**MODELS: 2017 & 2018 Z125 PRO & PRO KRT Edition
(BR125JHF/JHFAL/JHFL/JJF/JJFA/JJFAL/JJFB/JJFBL/JJFL/JJS/JJSL)**

ENGINE STALL

RECALL

**2017 & 2018 Z125 PRO & PRO KRT EDITION ENGINE STALL
IMPORTANT SAFETY RECALL
NHTSA RECALL NO. 17V-774**

NEW LABEL

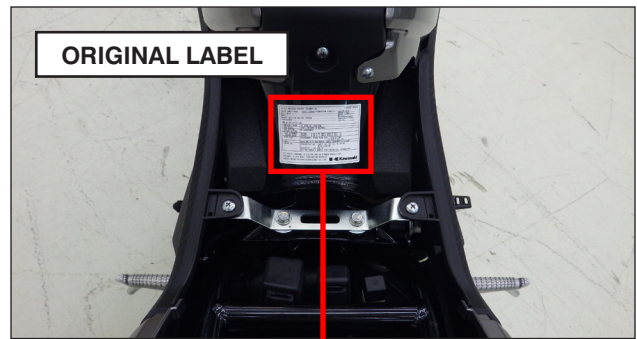
- Apply the new emission label on top of the “TUNE UP SPECIFICATIONS” section of the original label as shown.

TUNE UP SPECIFICATIONS	
IGNITION TIMING	0° BTDC AT 1800 RPM
IDLE SPEED	1800 ± 50 RPM IN NEUTRAL
IDLE AIR FUEL	NO ADJUSTMENT
MIXTURE SETTING	
VALVE CLEARANCE (ENGINE COLD)	INTAKE : 0.04-0.08mm(0.0016-0.0031 IN) EXHAUST : 0.08-0.12mm(0.0031-0.0047 IN)
SPARK PLUG	CR6HSA(NGK) SPARK PLUG GAP : 0.6-0.7 mm (0.024-0.028 IN)
FUEL	GASOLINE WITH ANTIKNOCK INDEX (RON+MON)/2 ≥ 87 MIN.
ENGINE OIL	SERVICE RATING : (API) SG, SH, SJ, SL OR SM WITH JASO MA VISCOSITY : SAE 10W-40 SEE THE OWNER'S MANUAL FOR ENGINE OIL INFORMATION.

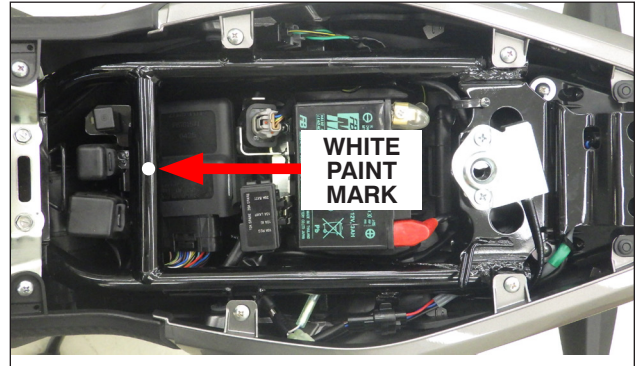
Make a white paint mark on the frame cross-pipe under the seat (as shown) to serve as repair verification.
